73-75 Avenue Road,  
NW8 6JD  
Basement Impact Assessment  
Audit

For  
London Borough of Camden

Project Number: 12336-65

Last saved	26/10/2016 15:03
Path	FGAav-12336-65-261016-73-75 Avenue Road-F1.doc
Author	F G Acheson BSc (Hons) MIStructE AMICE
Project Partner	E M Brown, BSc MSc CGeol FGS
Project Number	12336-65
Project Name	73-75 Avenue Road , NW8 6JD
Planning Reference	2016/1808/P

Drawing No. 1247 / SK01

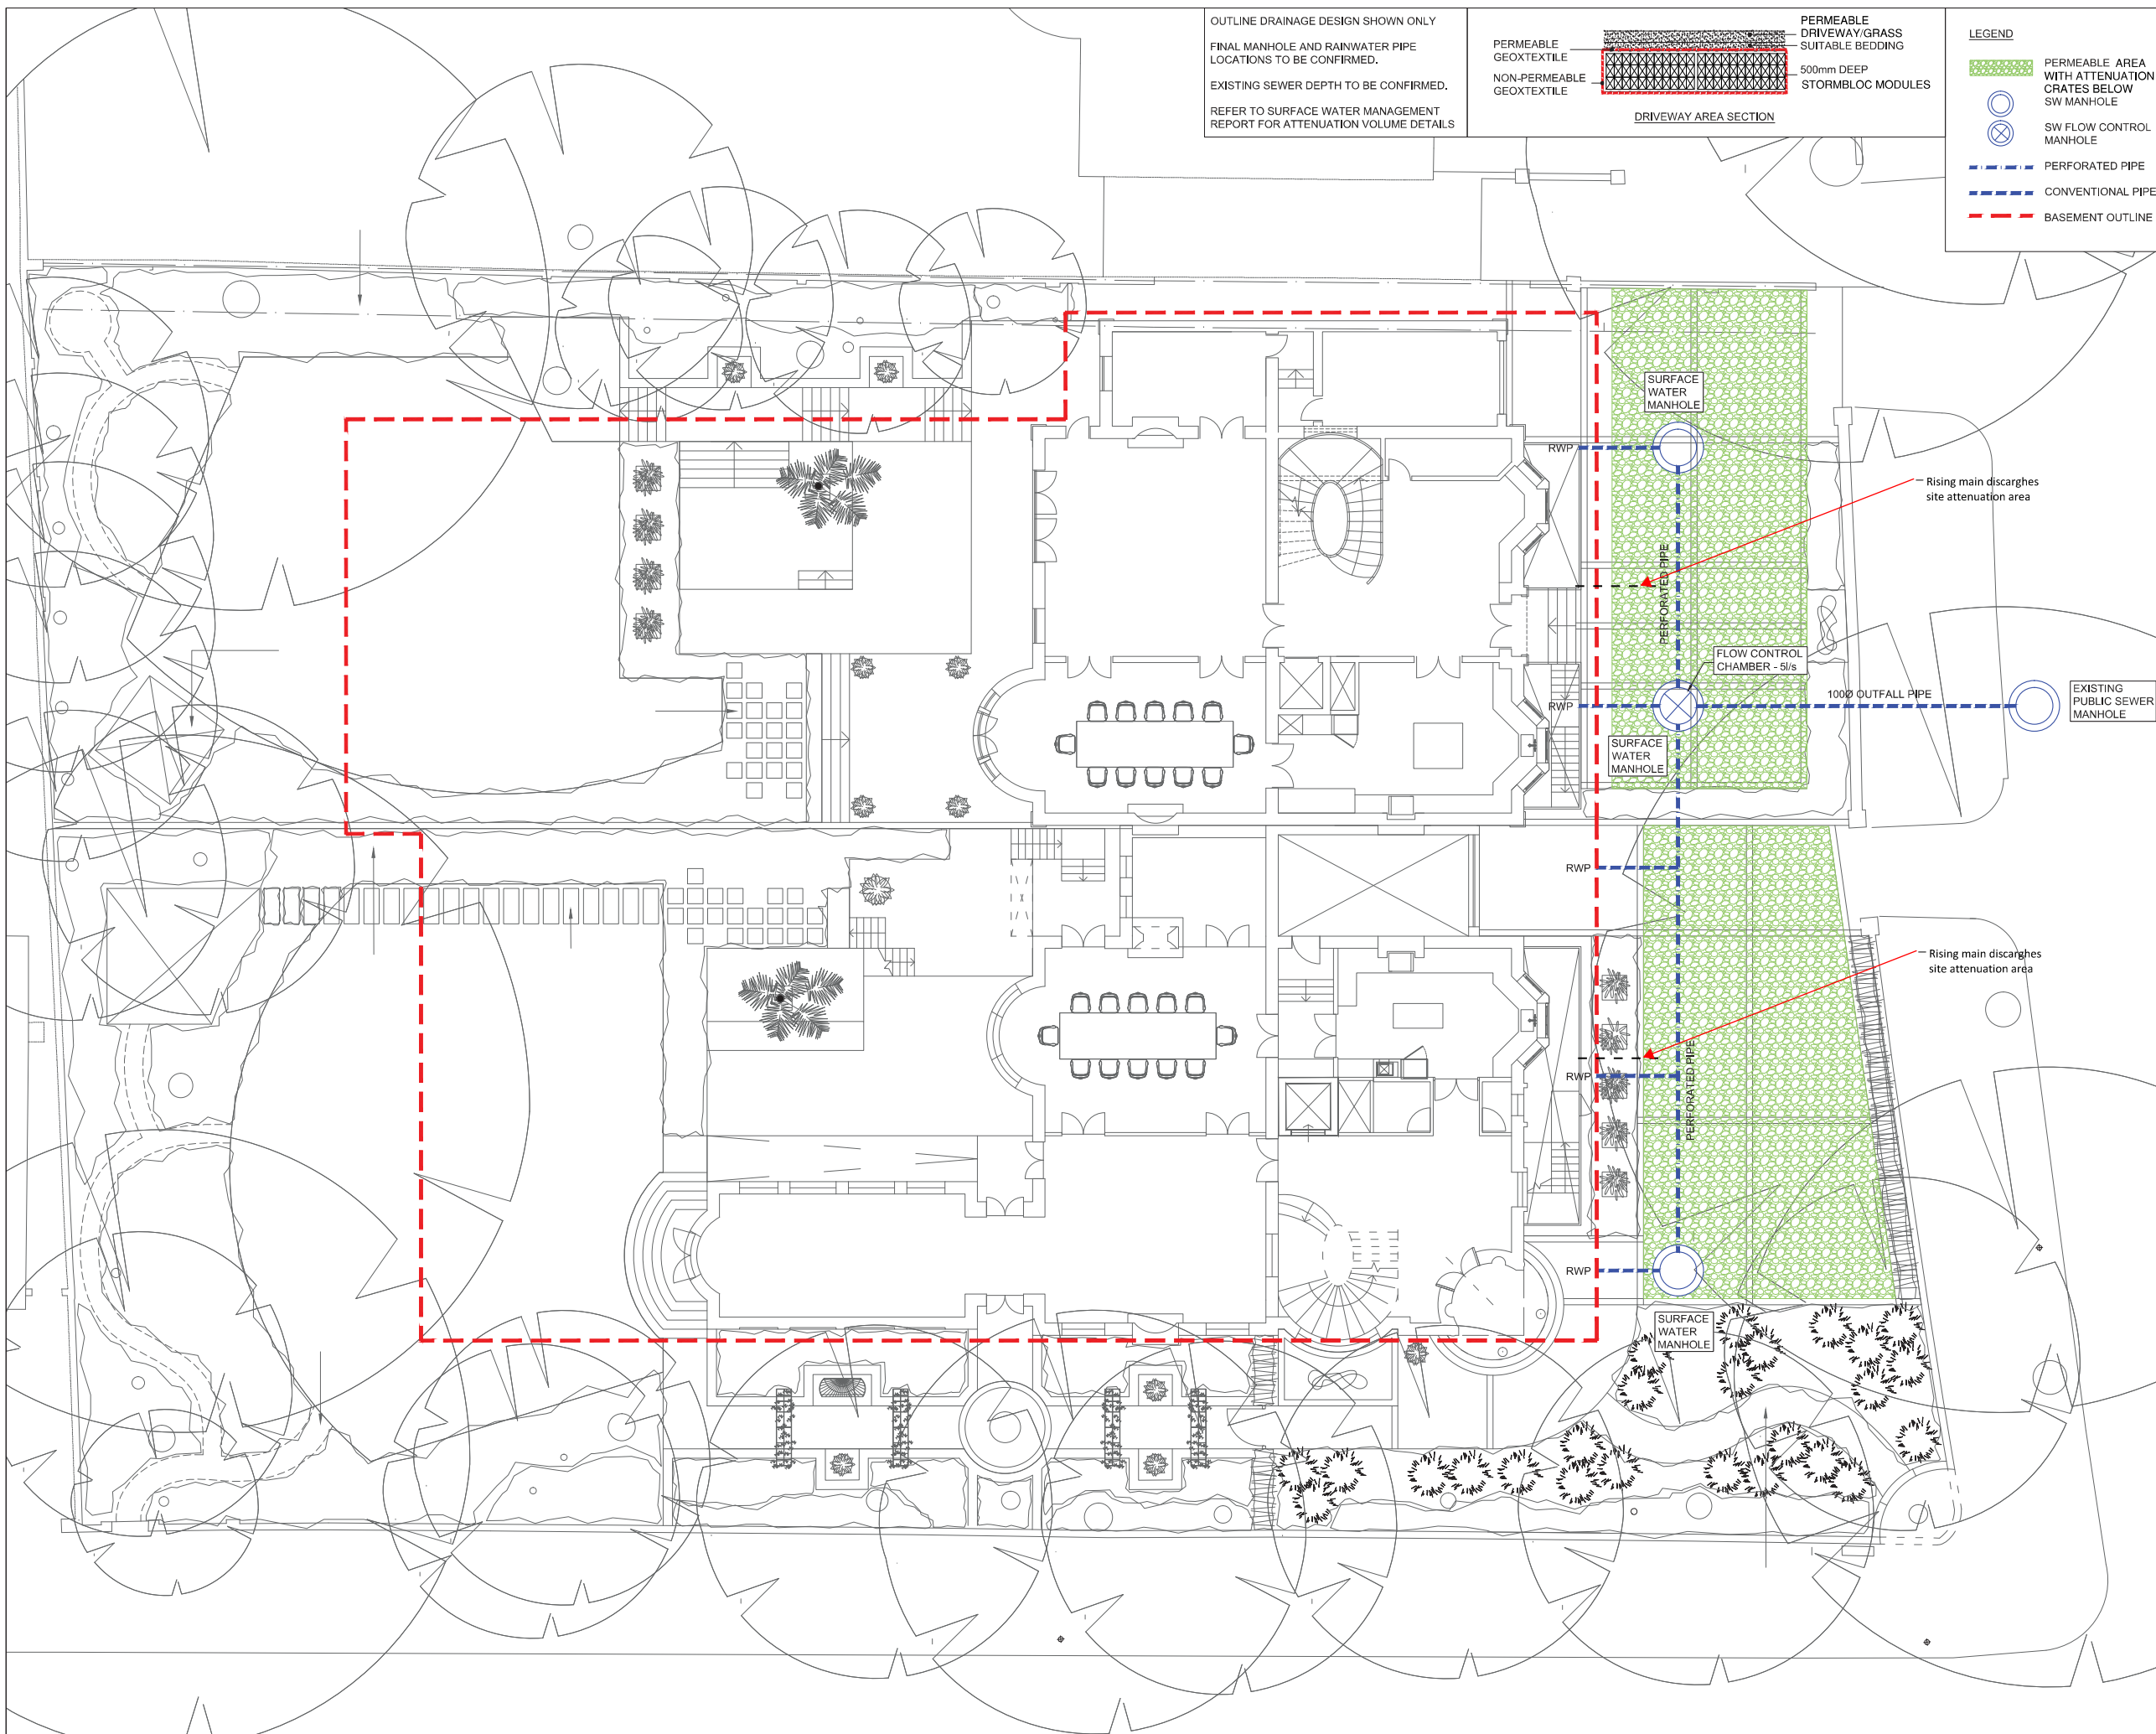
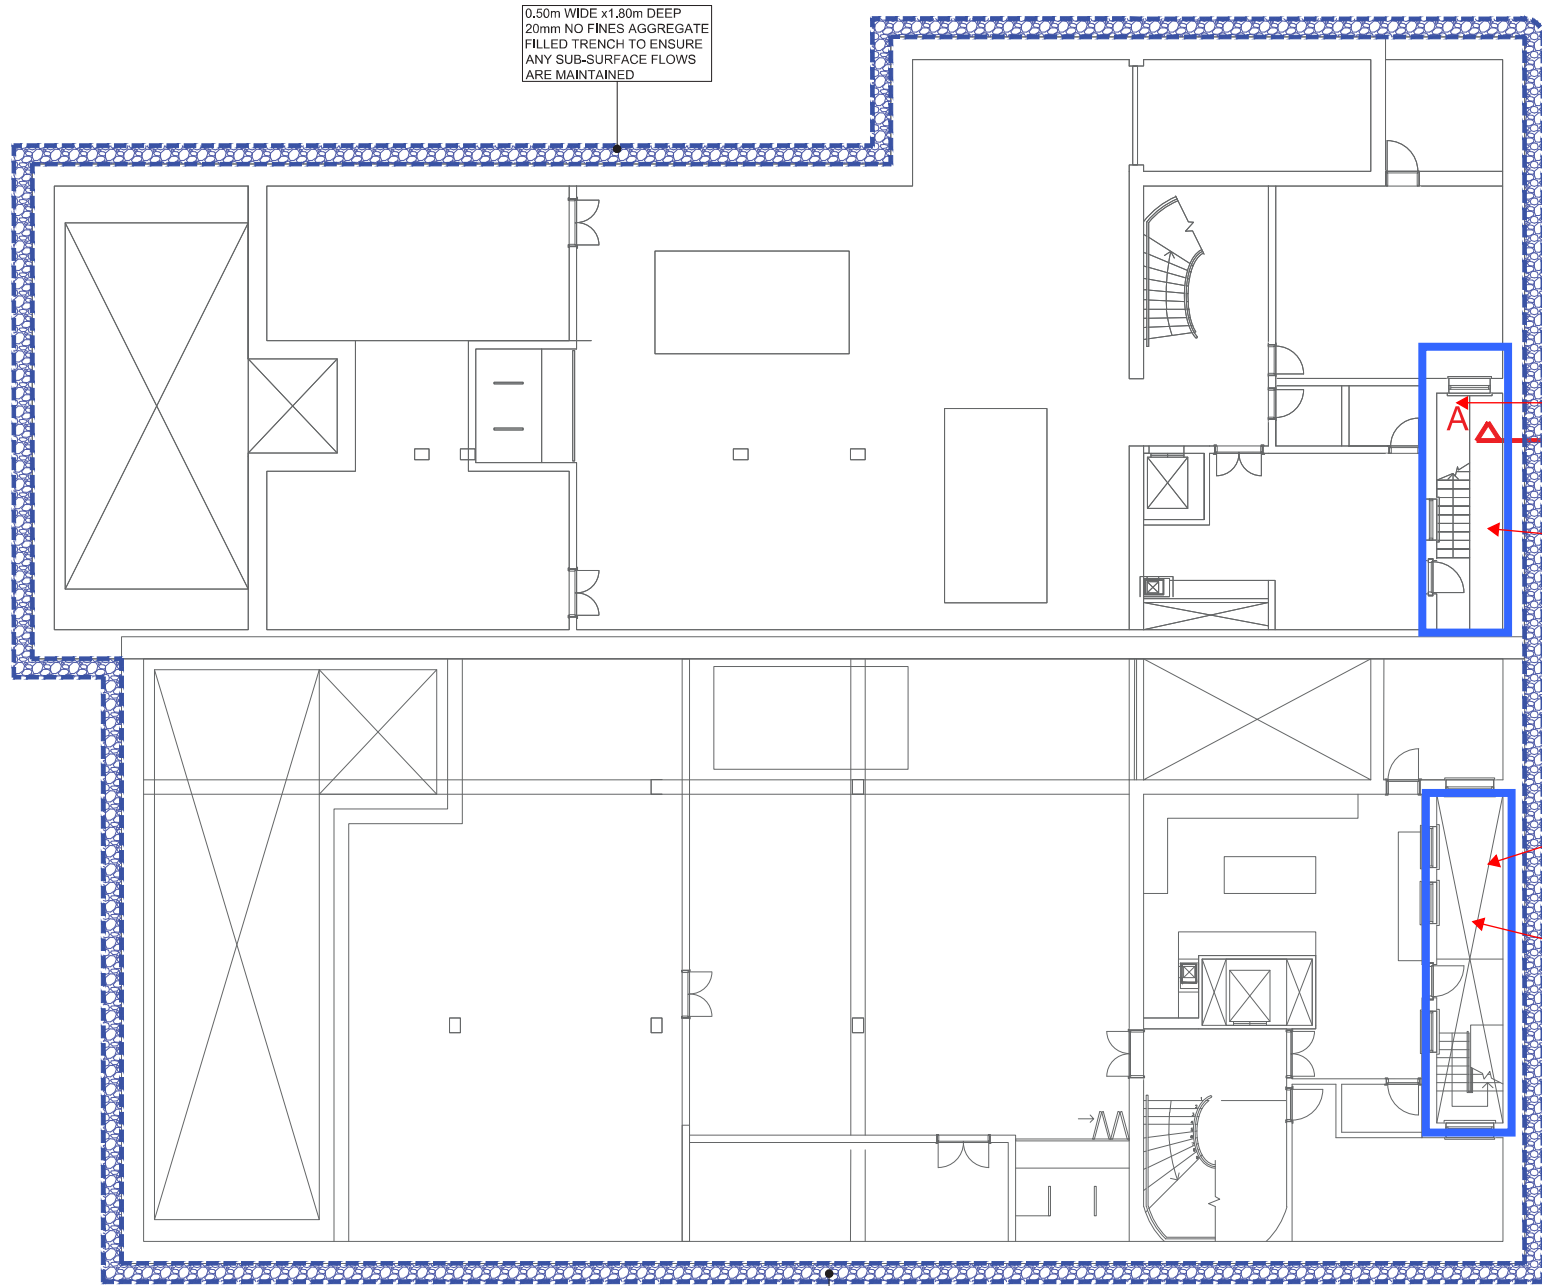
4.5. The site has been subject to surface water flooding in 2002 caused by excessive rainfall being unable to enter the public sewer network. The areas of hard surfaced areas and consequent surface water flow are increased by the current proposals. A Flood Risk Assessment has been carried out and a SUDS design is proposed including attenuation and control of flow from the site into the existing public sewer system. Site flows are to be limited to greenfield rates. The proposed attenuation location noted in the FRA does not accord with the landscaping proposals. Clarification is required on the nature of the attenuation which on the structural drawings is noted as being located beneath the basement slab.

**2. Surface flow and flooding - the response does not provide the clarification requested. SK01 does not indicate cellular storage as noted and the provision of the basement attenuation is not clearly identified in the surface water management**

The surface water attenuation is located at ground level at the front of each property (refer to SK01) This is provided using attenuation crates, which support the ground finishes above whilst containing within the cellar matrix the attenuated surface water.

Attached are drawings SK001 and SK002 which have been prepared by Heyne Tillett Steel and show the following in response to the above point:

SK001 - This shows the layout of Suds system which is created using stormblok modules beneath the driveway area of each property. These have been sized to provide the required attenuation as set out in the SWMP through the use of a Hydrobrake flow control manhole at the outlet.
